APPEAL SUMMARY

Appeal ID: 20419

Project Address: 2446 NW 28th Ave

LUR or Permit Application No.: 17-229160-CO

1 PLAN, FLOOR - LEVEL 01
1/8" = 1'-0"

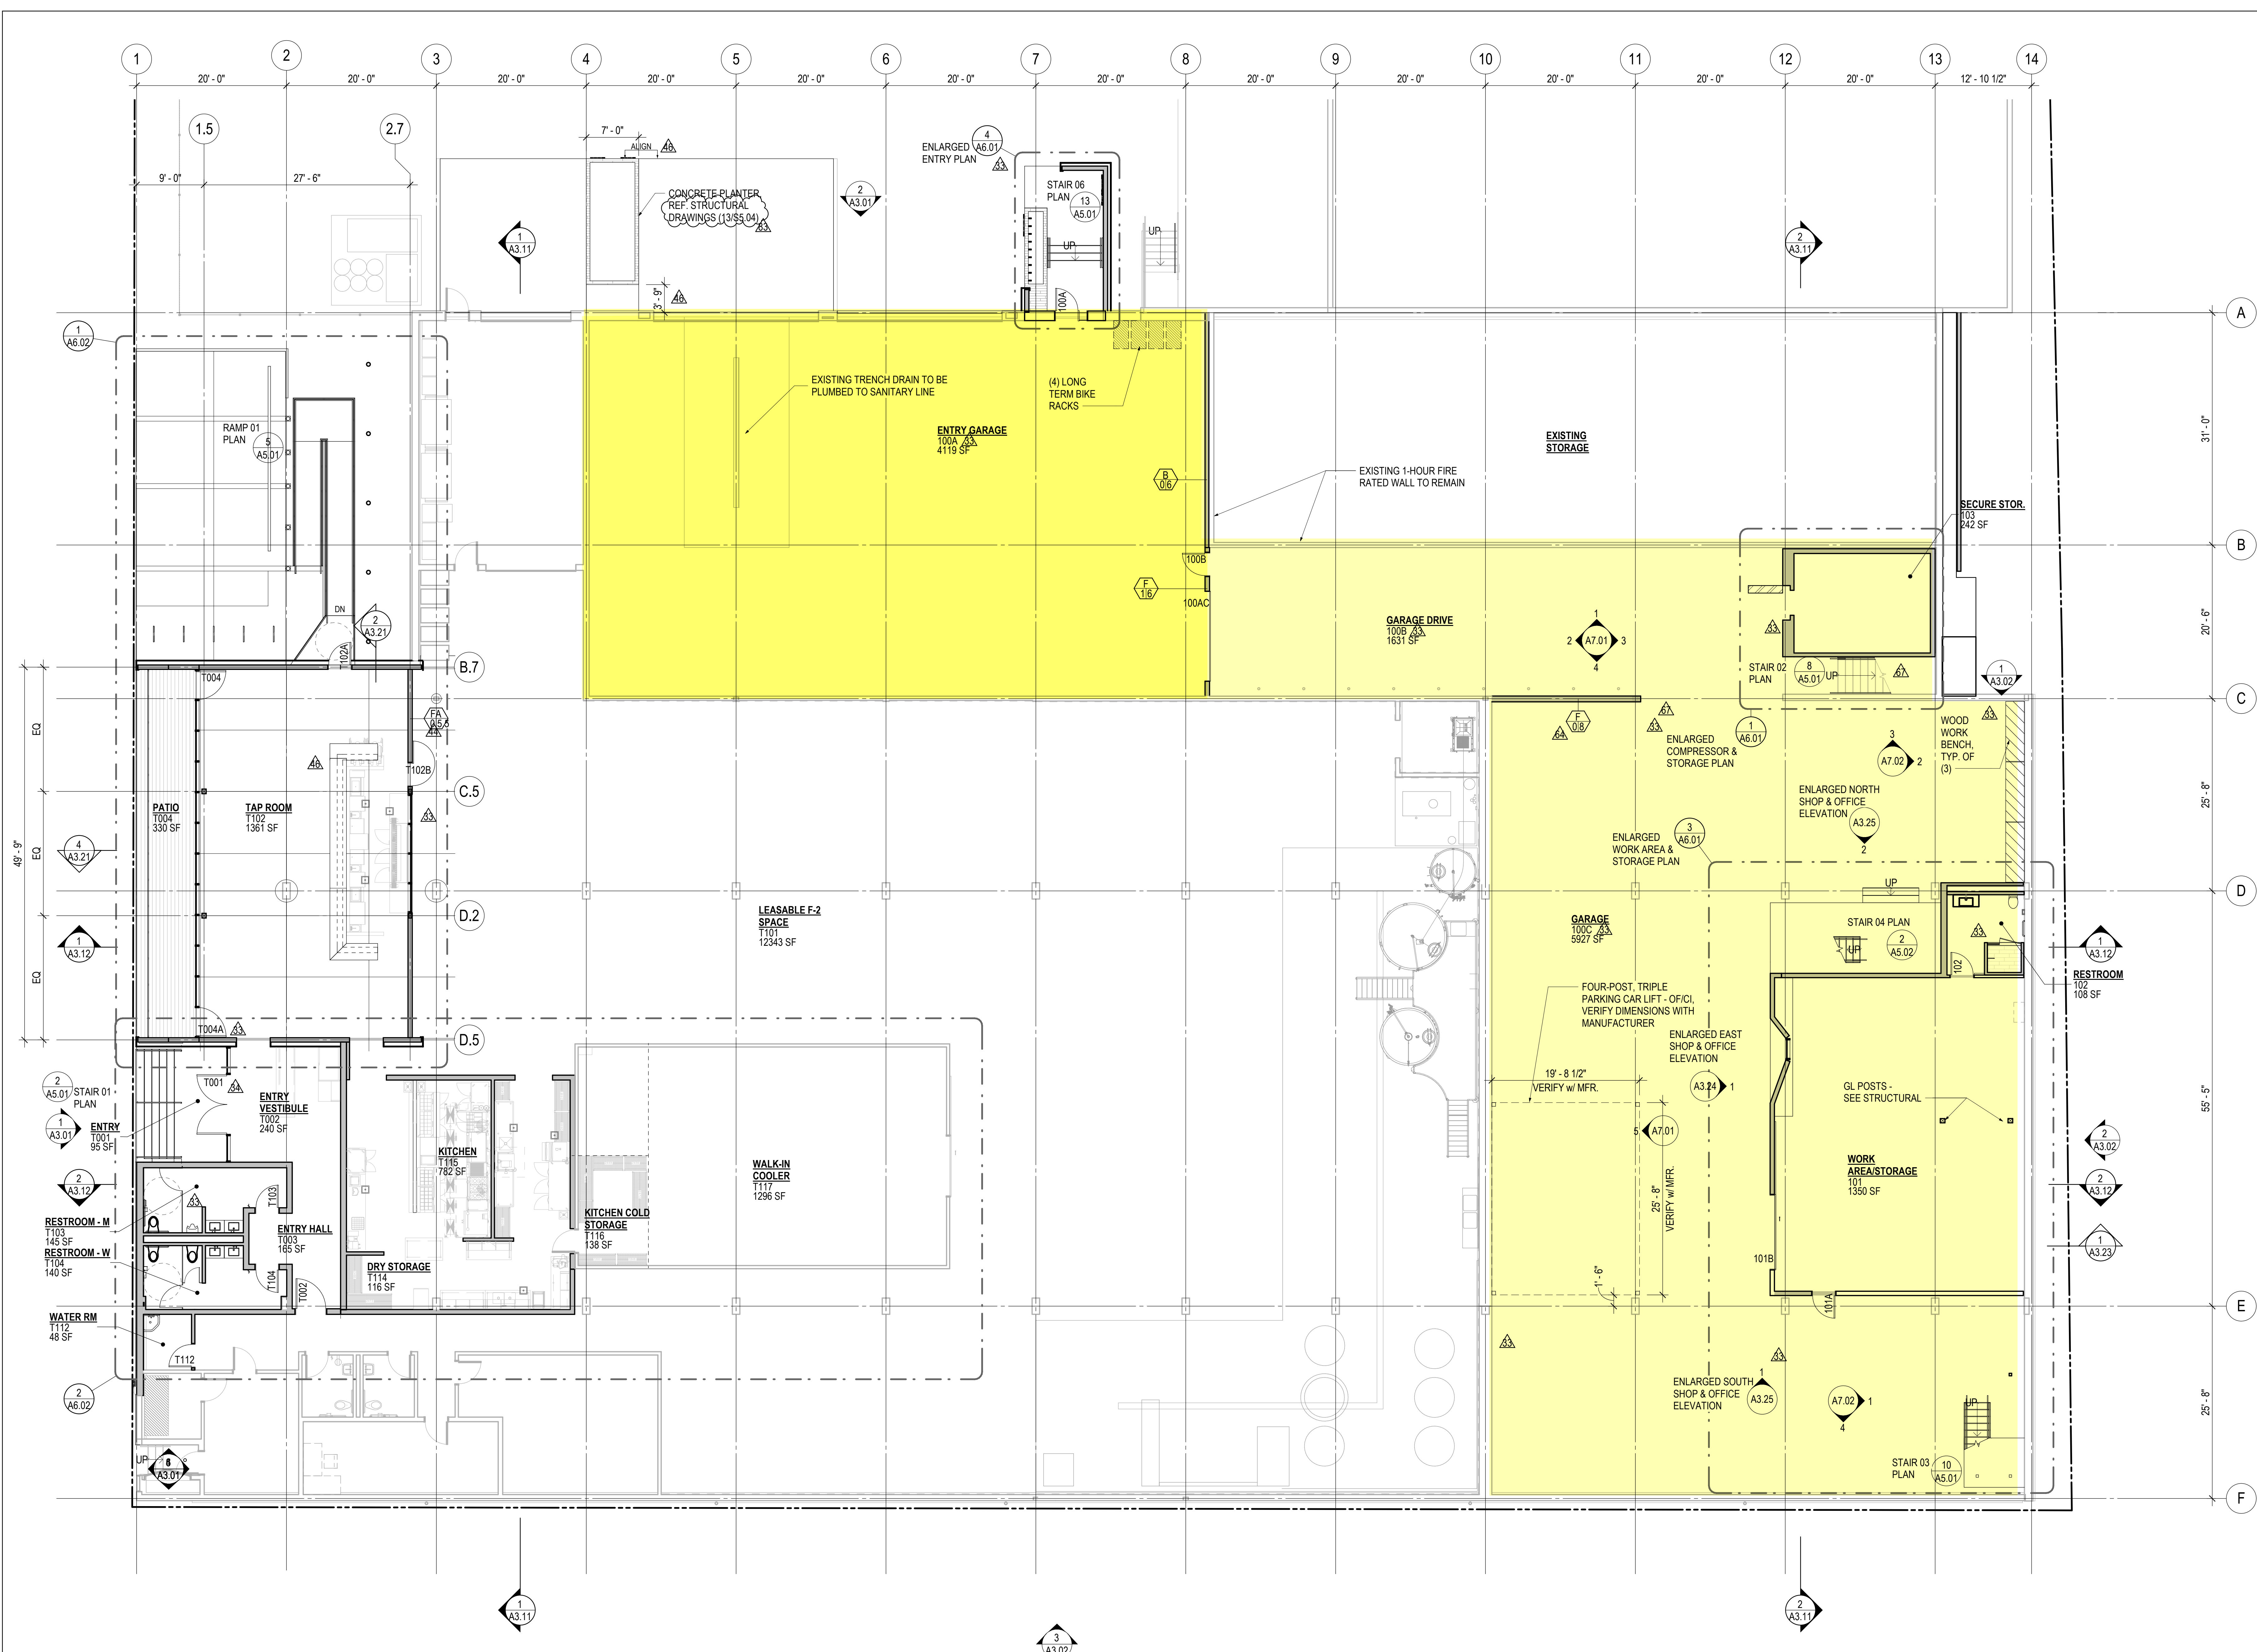
ORIGINAL TEXT - The door in question is located between two occupancy classifications and in a 1-hour rated dividing wall required per Table 508.4 (F-1 & S-2, reference attached Life Safety Plan, A0.12). Therefore, doors in fire barrier are required to be ¾ hour. We are proposing two doors in 1-hour rated wall:

While the sectional door is not rated, the proposed fire protection would be provided by full water curtain created through (2) additional Fire Marshal approved sprinkler heads on both sides of door installed per NFPA 13. Sprinklers are to be installed a minimum of 4 inches and maximum of 24 inches from the opening spaced at 6 feet on center. Sprinklers will be capable of wetting entire surface. In conjunction with the water curtain, the sectional door will close automatically by the actuation of fire alarm. The wall and swing door will maintain required rating. The proposed water curtain is only for the 12' door opening.

Neither door is part of prescribed egress path for the individual occupancy areas (reference attached Life Safety Plan, A0.12). F-1 space as shown in plan, has two exits leading to exterior and to property line to the east, S-2 space has one exit leading outside to exterior loading area to the north.

Alternate 3/4 hour fire rated assembly: Hold for additional information.
